System Impact Assessment Report

Pointe Aux Roches Wind Farm

CAA ID 2010-383

October 28, 2010

Figure 5 - Graphical load flow results demonstrating static reactive requirements

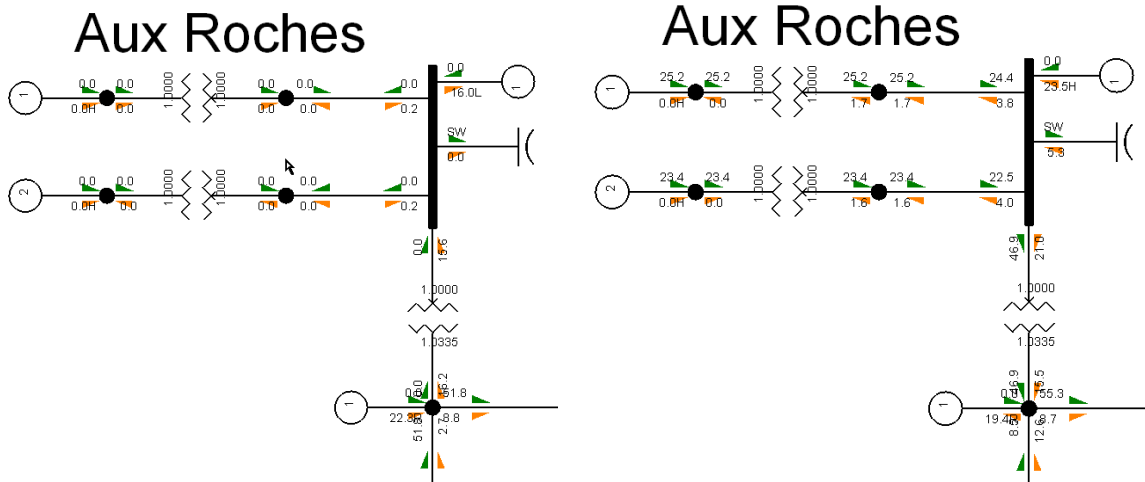
The proponent plans to install a dynamic compensation device with a ± 8.75 Mvar continuous capability, accompanied by $4 \times +5$ Mvar static capacitors and a -6Mvar static reactor. This compensation arrangement will be acceptable to the IESO.

The connection applicant has the obligation to ensure that the WF design and the reactive power compensation system takes into account the real electrical parameters and real limitations within the WF facility.

During commissioning tests, the proponent will be required to prove the reactive power compensation arrangement meets the requirements.

Figure 1: Pointe Aux Roches Wind Farm Connection to HONI Transmission System

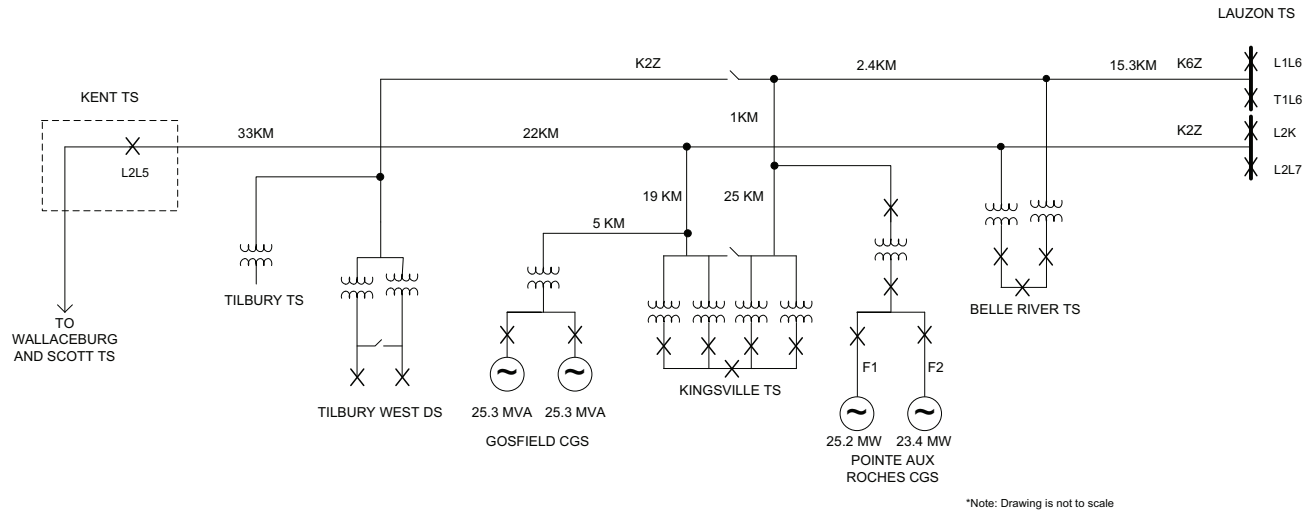
It is feasible for Pointe Aux Roches Wind Farm to connect the proposed 48.6 MW generation at the location in Figure 1 as long as the following changes are made:
